County of Loudoun
Department of Planning
MEMORANDUM

TO: Darren Murphy, Project Manager
Land Use Review

FROM: Melanie L. Wellman, Planner *new*
Community Planning

SUBJECT: SPEX 2005-0040 Holtzman Oil

Figure 4
Existing Peak Hour Traffic Volumes

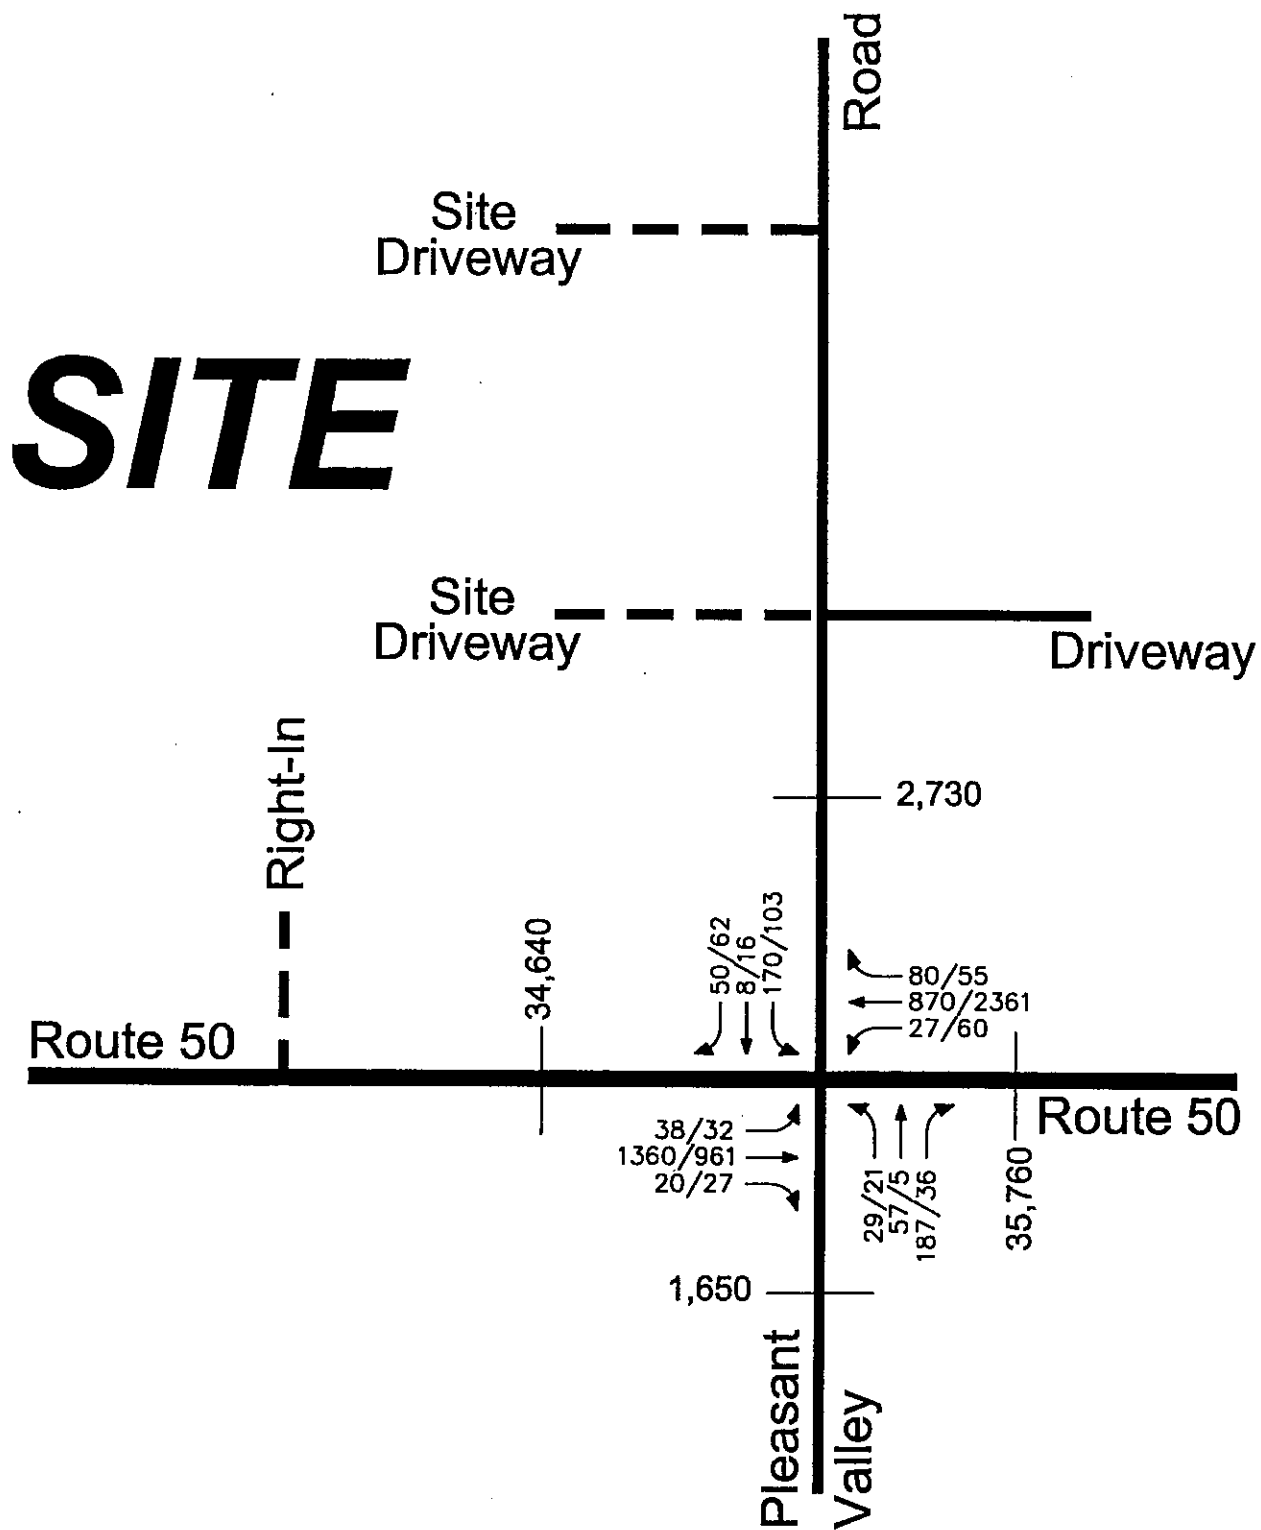
- According to the report, the volumes in figure 7 on page 18 are determined by growing the existing volume at 1% for 3 years and adding the volumes from the other developments. Using figure 4, a 1% growth rate and the figures in appendix F, the resulting volumes do not equal those shown in figure 7. Please explain.
